Recall Campaign

NHTSA#: 18V-074 TC#: 2018-071 Job Code: 9904374 Flate Rate: 0.3 hr

2018 Open Range Light Travel Trailer

CHANGING THE FEDERAL CERTIFICATION LABEL

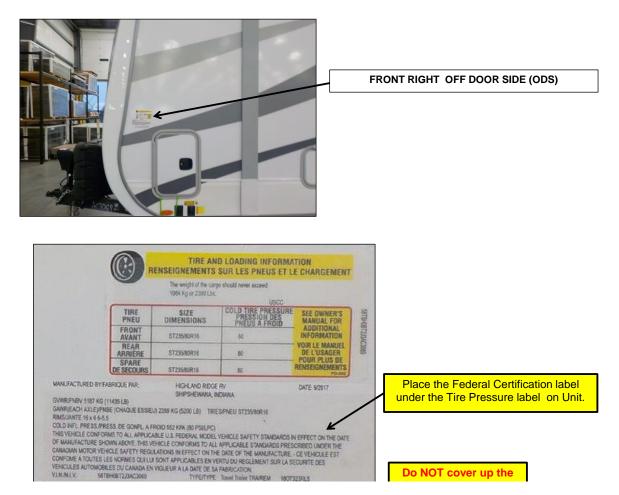
Replace Federal Label due to incorrect GAWR stated as 5100 lbs.when correct is 4400 lbs.

Remove existing label

- 1. Locate the approprate label on the outside off door side (road side) front of the unit. Remove the existing Federal Certification Label
- 2. Using isopropyl alcohol and a shop rag, remove any adhesive residue from the surface where the original label had been. Allow the area to dry for at least 30 seconds.

Apply new label

Remove the protective back from the new label. Align the new label in the same location of the original label and apply it to the surface. Remove any air bubbles from the label.
NOTE: Do not attempt to remove or adjust the label once it has come into contact with the surface. Doing so may damage the label or cause it not to adhere properly to the surface.
